TRANSPORT ASSESSMENT
VOLUME 5
PROPOSED McDONALD'S DRIVE THRU
LARCHWOOD AVENUE
HAVANT

ADL/AJM/2256/30B

November 2011

Document:	Transport Assessment Volume 5
Project:	Larchwood Avenue, Havant
Client:	McDonald's Restaurants Ltd
ADL Reference:	2256

Figure 2A Queue Analysis Purbrook Roundabout

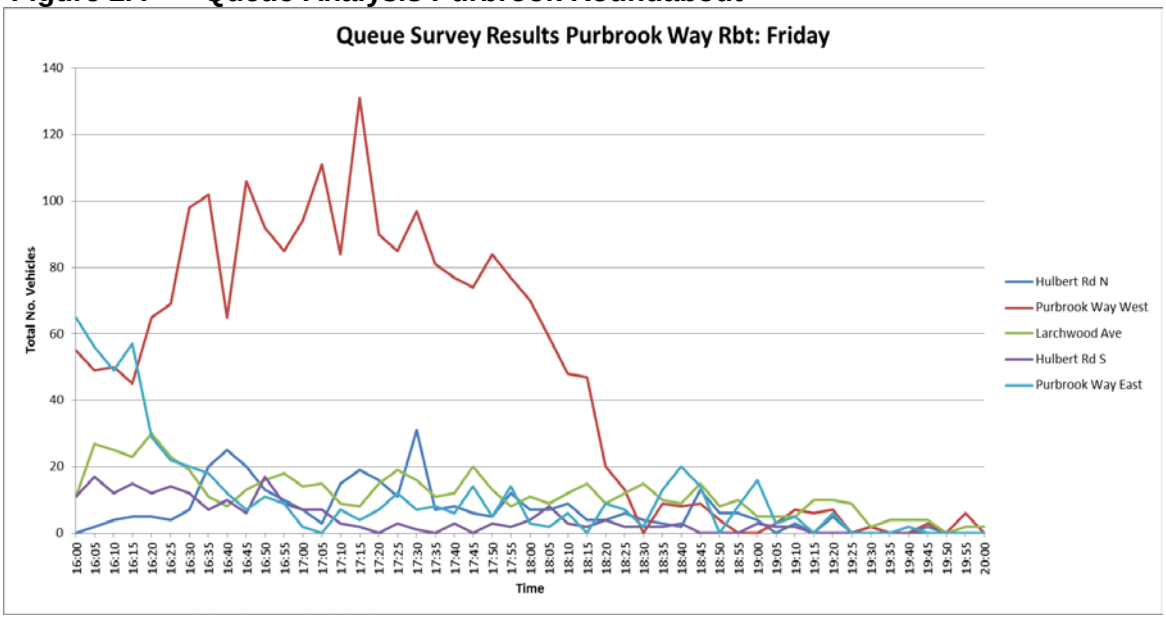
GW said that the peak level of queuing at the Purbrook Roundabout may represent relatively short period of intense queues and that this should be set in context of the off peak queuing situation. The TA assesses the impact of the McDonald's during the peak period and this should be compared to the impact during the off peak periods.

ADL to provide a brief assessment of the peak and off peak queues at the Purbrook Roundabout and the impact of the McDonald's.

2.1.2 The surveyed queues on each arm of the roundabout for the Friday survey period (16:00-20:00 hours) are shown in Figure 2A below. Purbrook Way West is subject to higher levels of queuing (16:30-18:30 hours) but this is not consistent with the situation on the other arms of the roundabout. The peak queue lengths on Purbrook Way, represents an intense but relatively short period of activity. The off peak queues on all arms are much lower.

2.1.3 The hourly additional traffic and diverted trips returning on Larchwood Avenue generated by the McDonald's on a Friday on each arm of the roundabout are set out below. This traffic impact per 5 minute interval gives the likely impact on the queue length at the roundabout.

Arm	Hourly Additional Trips Circulating Rbt	Impact/5-min interval on queues
• Hulbert Rd N	+4	+1
• Purbrook Way W	+9	+1
• Larchwood Ave	+66	+6
• Purbrook Way W	+12	+1

2.1.4 This level of traffic impact is not considered material in traffic engineering terms.

2.1 Fareham
2.2 St Leonards
2.3 Havant

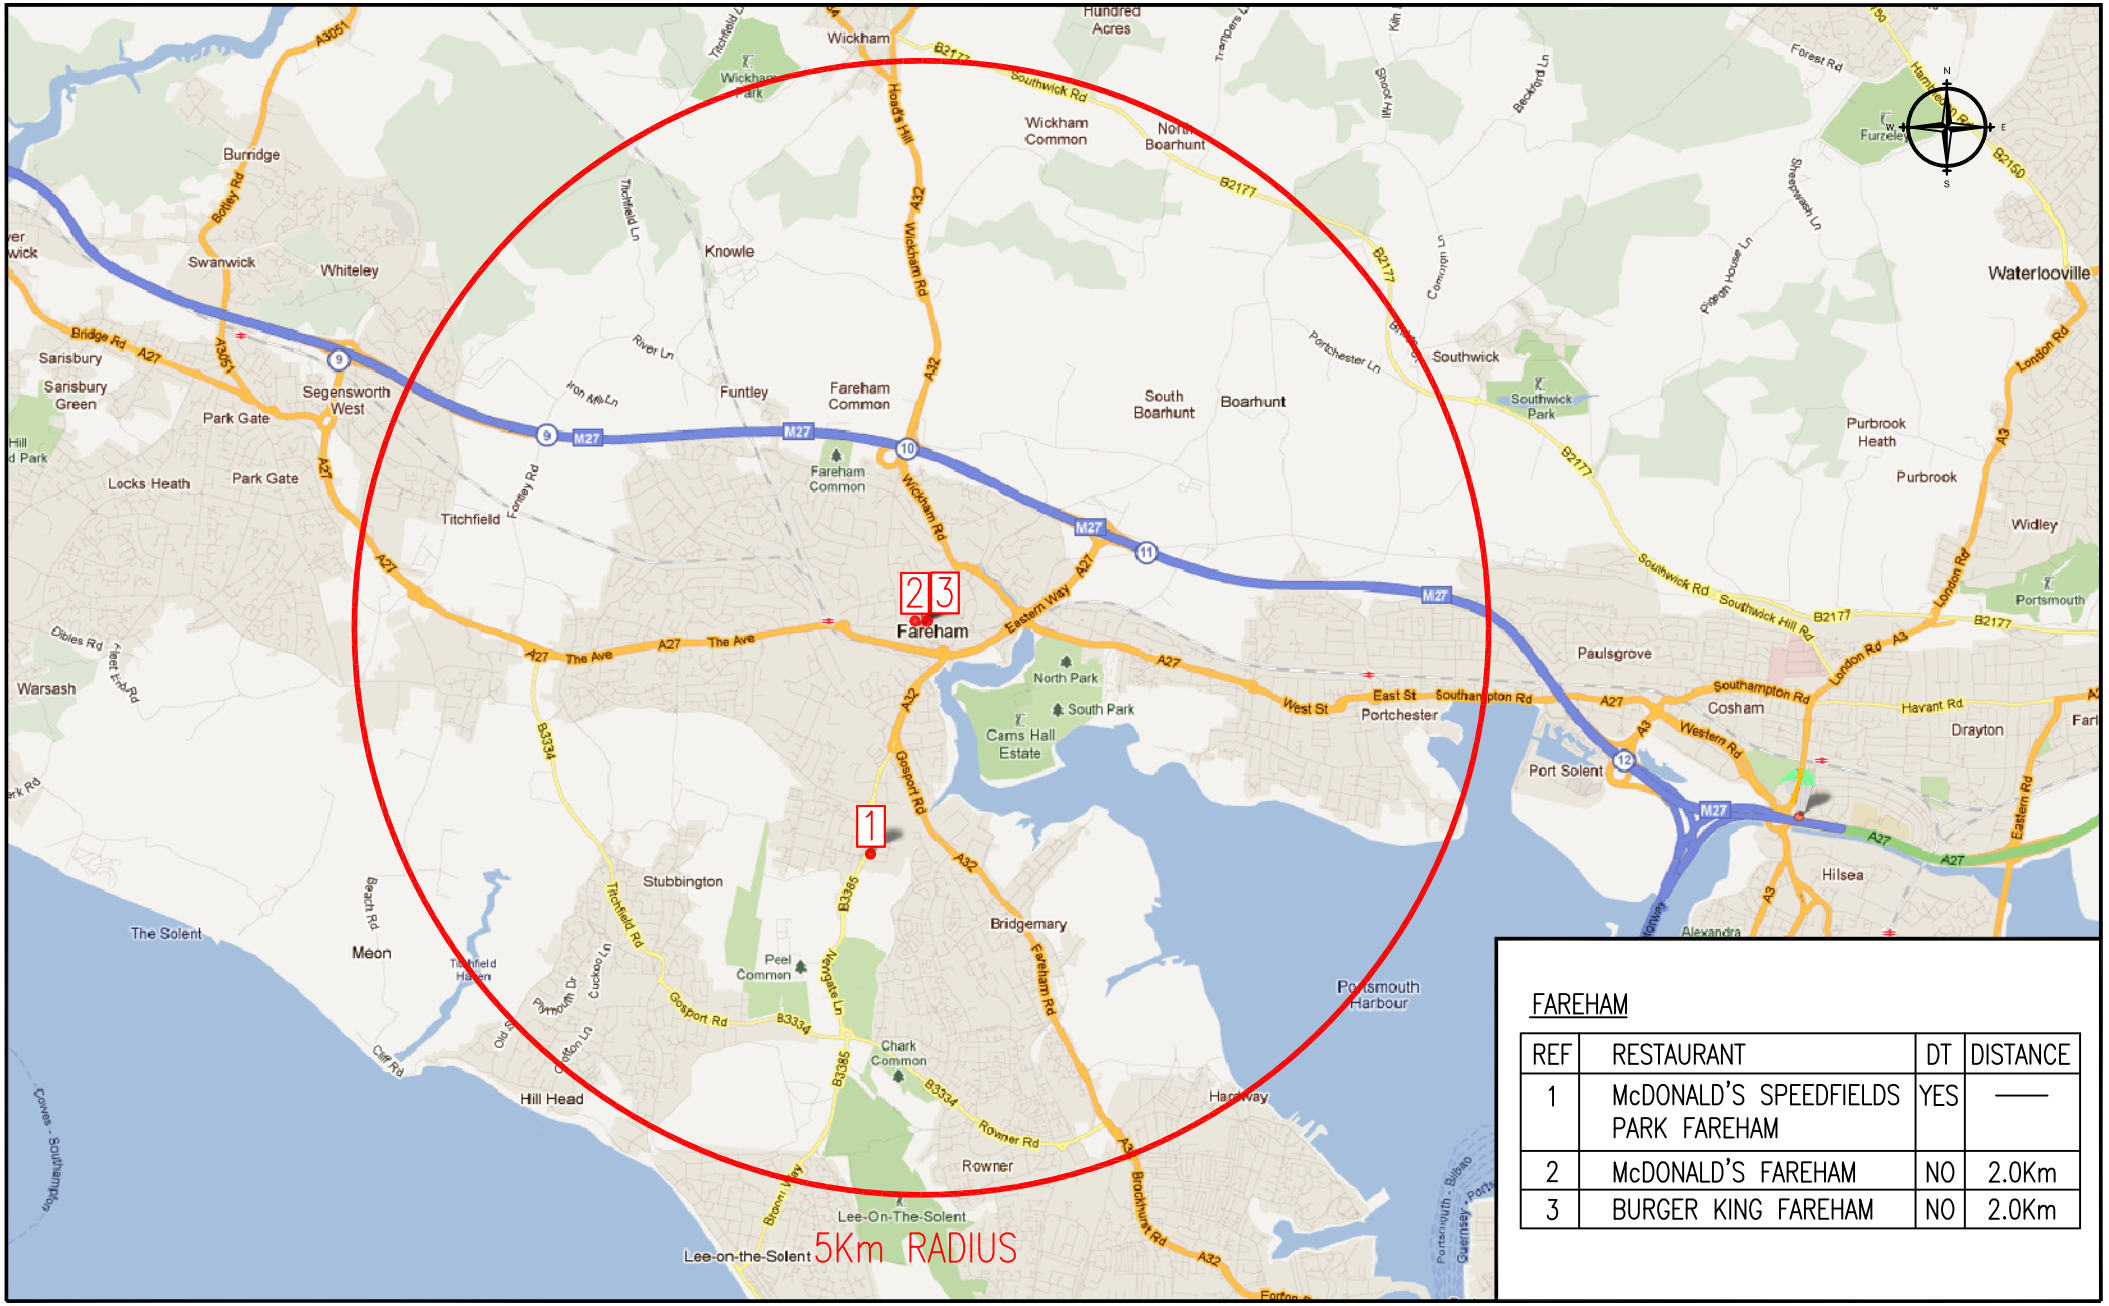
GW required to have demonstrated to him how the factors used in the model to calculate trade at Havant differed from the levels of trade occurring at St Leonards and Fareham.

ADL to provide evidence either from TRICS or from the McDonald's modelling process (to support the proportional differences in trade between Fareham/St Leonards and the proposed restaurant).

2.3.3 Fareham and St Leonards have been selected as comparable to Havant due to their location near similar retailers. The data for Fareham, St Leonards and Havant is summarised in Tables 2A and 2B below and plans showing the surrounding restaurants are included in Appendix 2.0.

2.3.4 McDonald's model makes adjustments to allow for differing factors likely to affect sales performance. In this case we have been advised that, the key factors are number of McDonald's restaurants and all three population types shown in Table 2B.

2.3.5 The above demonstrates Havant will have significantly more competition for trade than the Fareham and St Leonards restaurants and resulting sales are expected to be lower. Consequently, this is why McDonald's have provided ADL with the pro-rata factors in ADL TA Vol 2 Section 7.2.
